June 24, 2022

From: Alameda County Wind Repowering Technical Advisory Committee

Re: Mulqueeney Ranch Micro-siting Recommendations (Supporting Documentation)

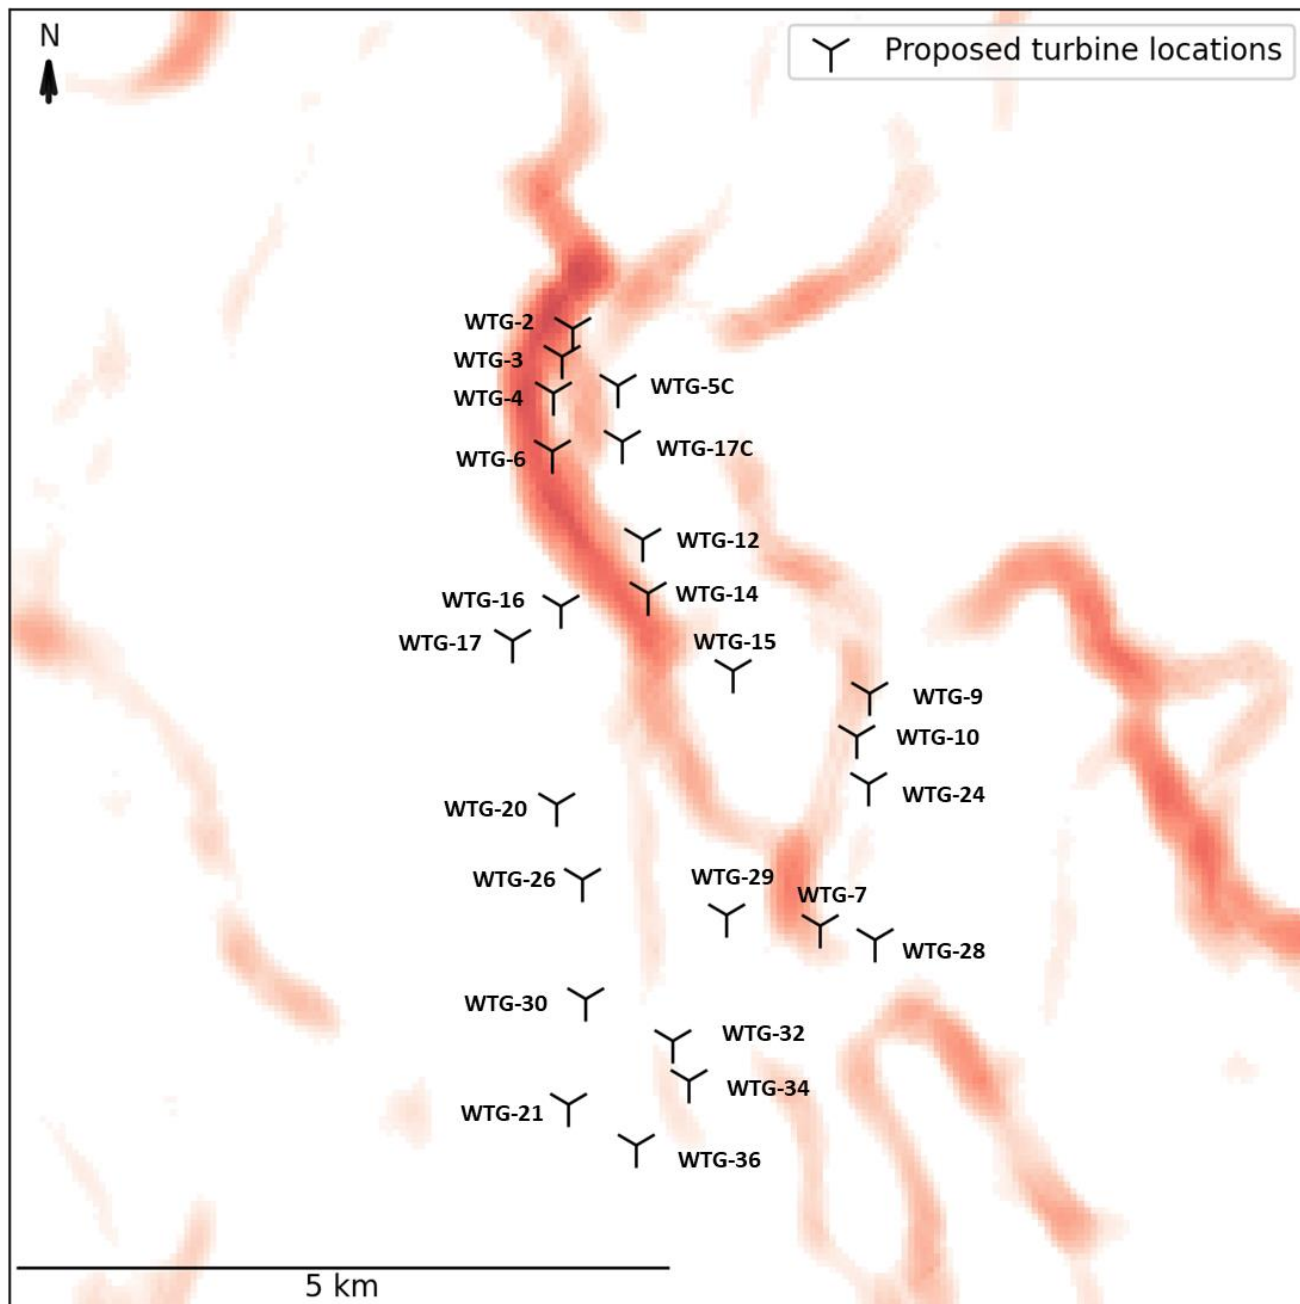
- golden eagle observed flight behavior and telemetry points of adult and juvenile golden eagles interacting with Rotor-Swept Area of Golden Hills WTG-32 and the airspace of the proposed turbine locations near proposed Project turbines WTG-2, WTG-3, and WTG-4 on December 10, 2021 (Fig. 6; Bell 2022a);
- NREL modeling of predicted GOEA flight patterns (Fig. 7; Sandhu 2022 [Appendix C]);

- *TAC findings:* The telemetry observations (Figs. 4-6) and modeled data (Fig. 7) correspond with golden eagle high-use areas as identified in Eagle Use Surveys conducted by ICF (2020b; Fig. 3), especially in the vicinity of proposed turbines WTG-2, WTG-3, WTG-4, and WTG-6 in the northwest of the Project footprint. Golden eagle use is also heavy at another turbine location (WTG-14).
- *Related TAC Recommendations (GOEA Consideration 3): Turbine Removal and/or Phased Approach to Turbine Approvals.*

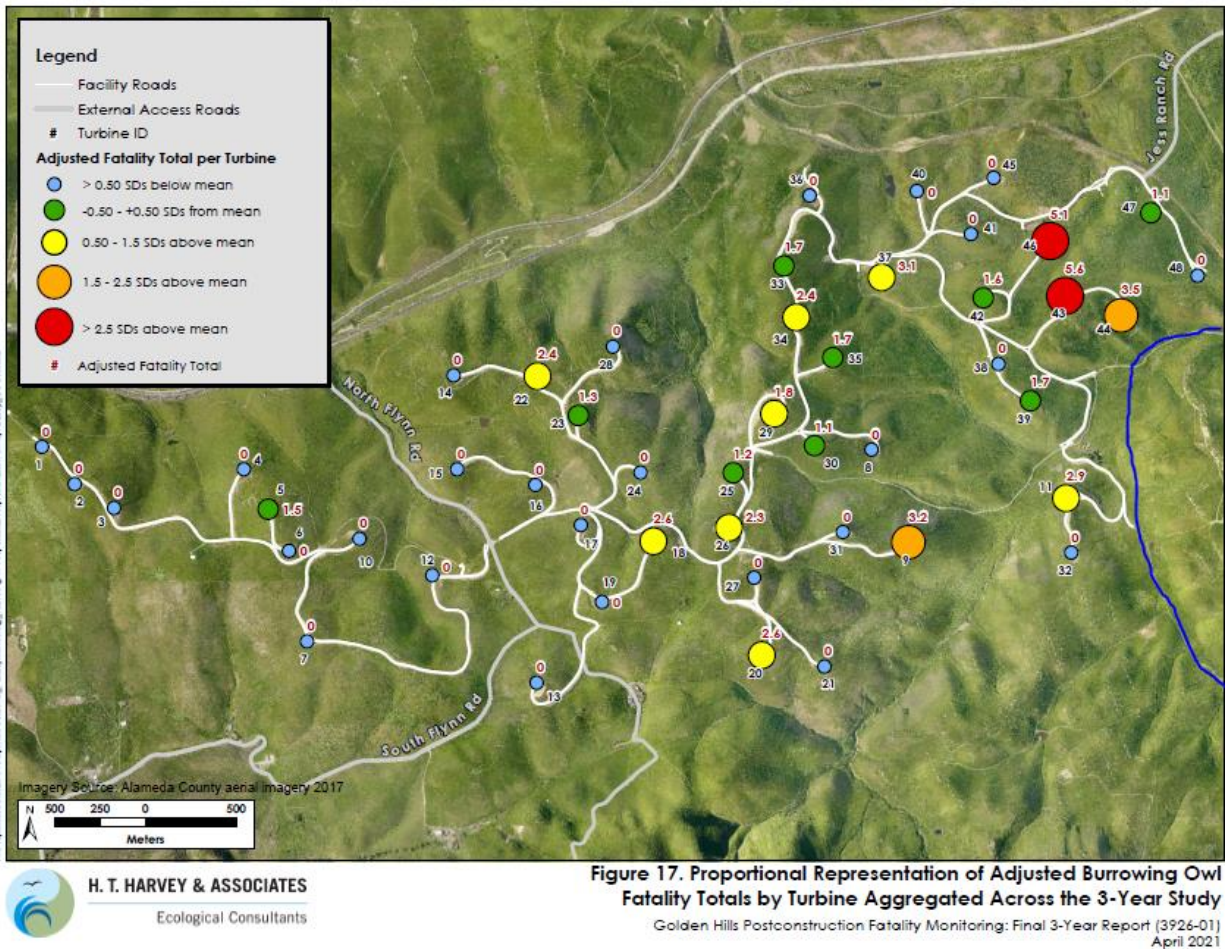
- *Reference data:* burrowing owl fatality data at adjacent Golden Hills project (occurrences and distribution relative to nearby proposed Project turbines) (Figure 8; H. T. Harvey & Associates 2021)
- *Related TAC recommendation (BUOW Consideration 3): Turbine Re-siting and/or Burrowing Owl Curtailment and Distance from Rotor to Ground.*

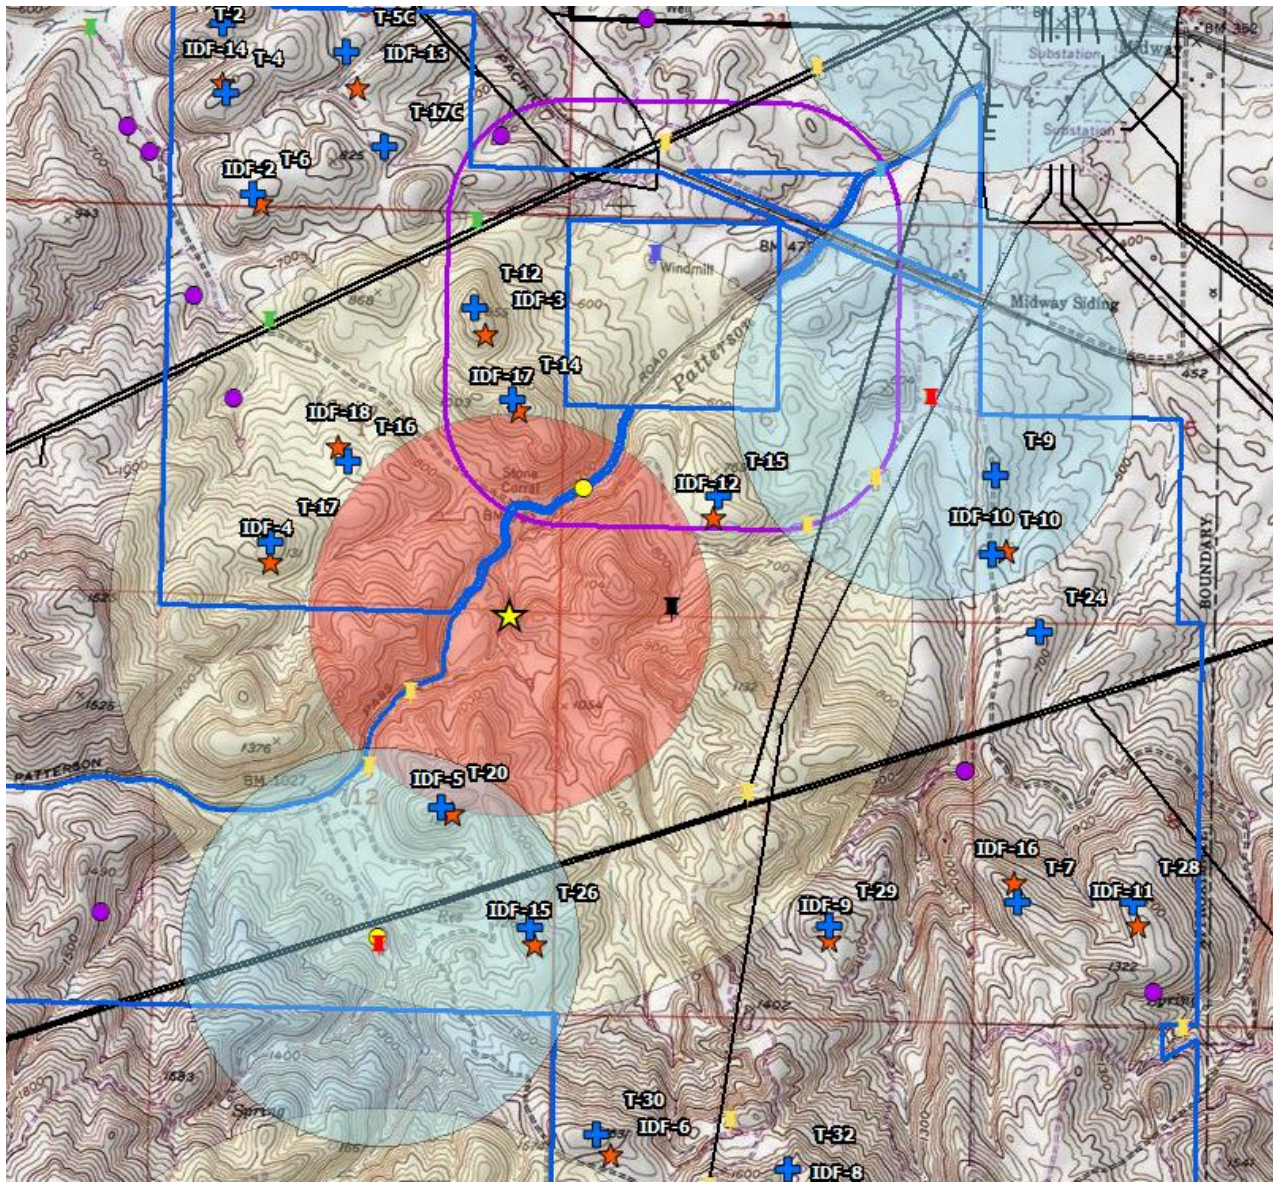
- CDFW Comment #2-15 on Draft SEIR (ICF 2021: Appendix H-2): “... All turbines located within one mile of a golden eagle or Swainson’s hawk nest or communal roosting area, and within 0.5 mile of any other raptor nest or tricolored blackbird colony, should be curtailed. Curtailment should occur each year that active nests are detected during surveys. Curtailment of turbines located near raptor nests and tricolored blackbird colonies should be implemented during daylight and crepuscular hours during the entire nesting season, within 0.5 mile of known other active raptor nests during the breeding season or until young have fledged or the nests have been determined by a qualified biologist to be unsuccessful.”
- Red-tailed hawk nest locations including perching/nesting tree located in riverine downslope of northwestern portion of the project (Fig. 9).

- *Reference data:* Known nest locations within Project footprint (Fig. 9) and fatalities reported at adjacent Golden Hills (H. T. Harvey & Associates 2021; Fig. 10). Take also is associated with areas of observed high densities of ground squirrel activity (Table 1). TAC member observations of ground squirrel activity during site visits to Golden Hills and Project footprint in 2022. Reports of observed high densities of ground squirrel activity (Table 1). USFWS comment #1-16 on Draft SEIR (ICF 2021 Appendix H-2). The PEIR (Alameda County Community Development Agency 2014) estimated the following totals for red-tailed hawk fatalities Golden Hills and Golden Hills North: 44/year and 12/year, respectively. D. Bell report of red-tailed hawk and other nest observations on decommissioned Patterson Pass Wind Project turbines (Bell 2022d).

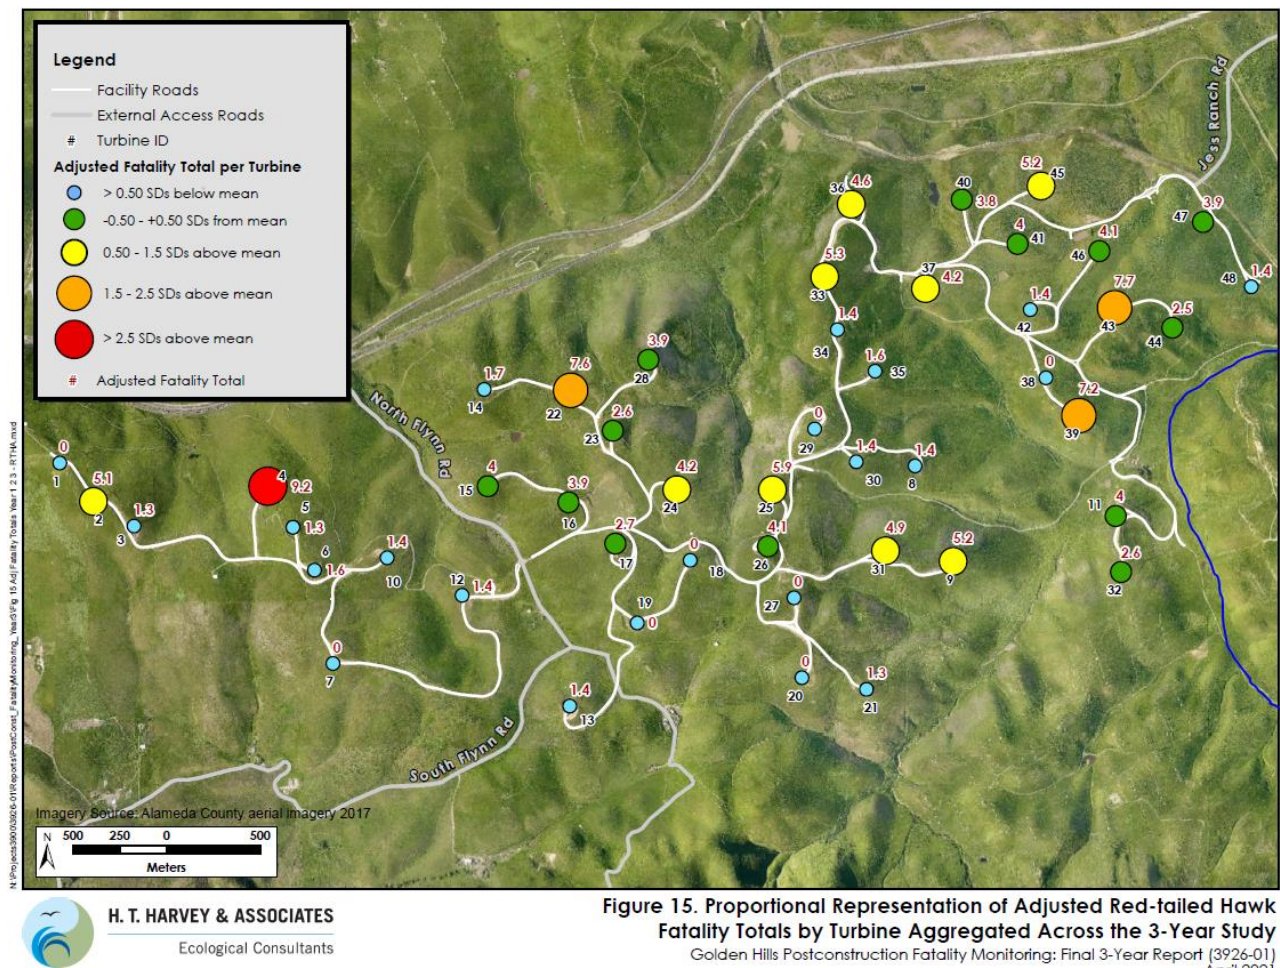
- See Figure 10 (H. T. Harvey & Associates 2021).

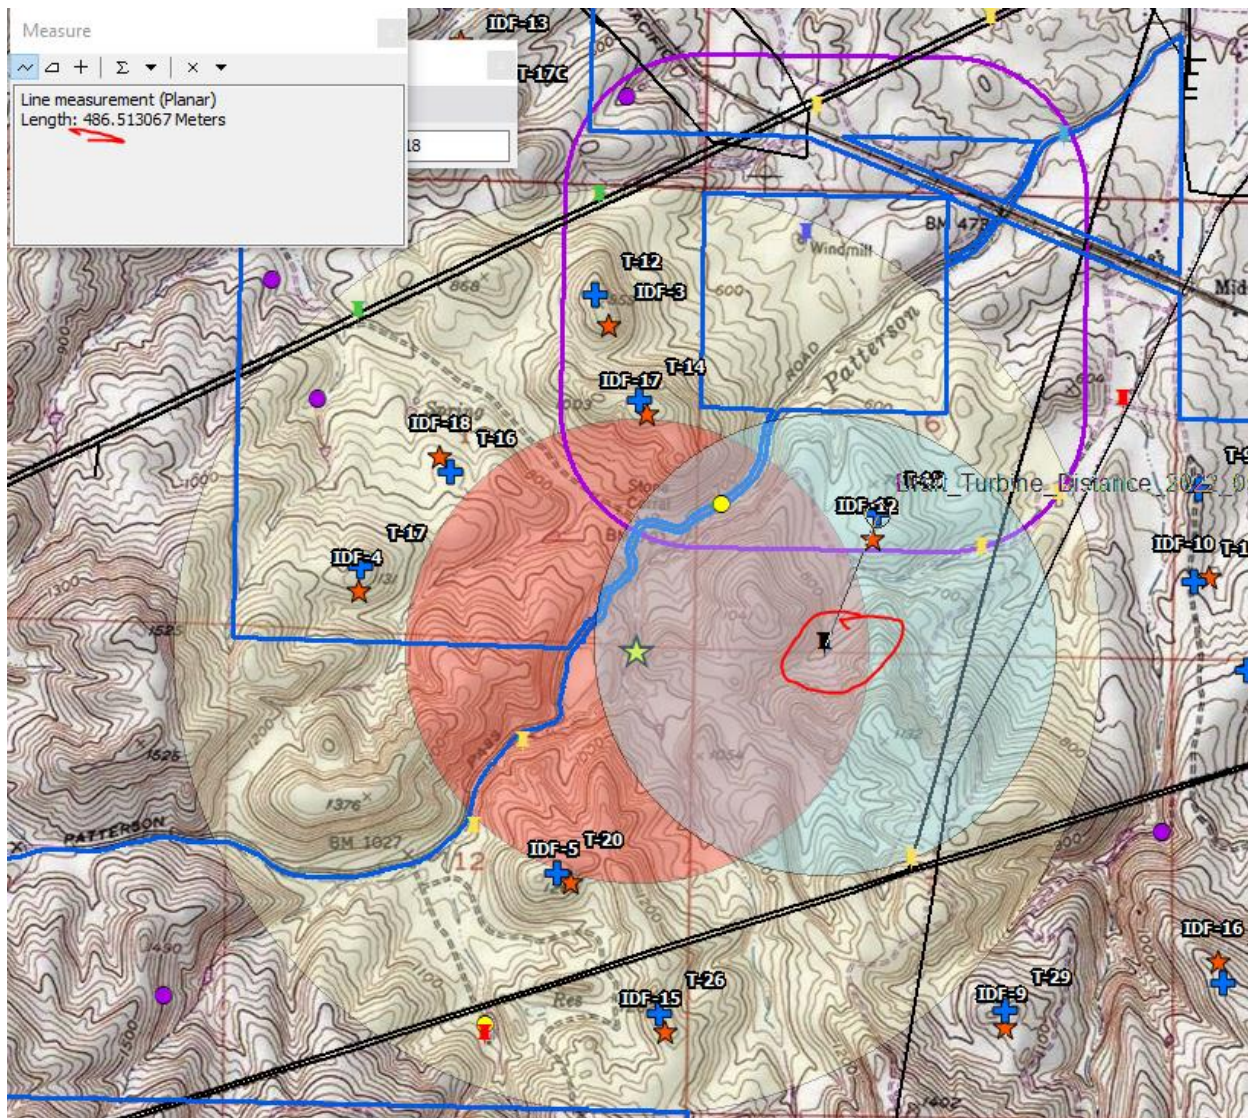
Additional figure – Figure 12 – shows location of active prairie falcon nest observed within Project footprint in May 2022 (Bell 2022c). TAC recommendation for prairie falcon nests falls under *Curtailment Other Raptors*, described above.

- *Curtailment Other Raptors:* Consistent with CDFW comment on Draft SEIR #2-15 (ICF 2021 Appendix H-2), we recommend the above red-tailed hawk curtailment measures also be considered for other sensitive raptor species and be included in the Project's Avian and Bat Protection Plan (per PEIR/SEIR Mitigation Measure BIO-11a).
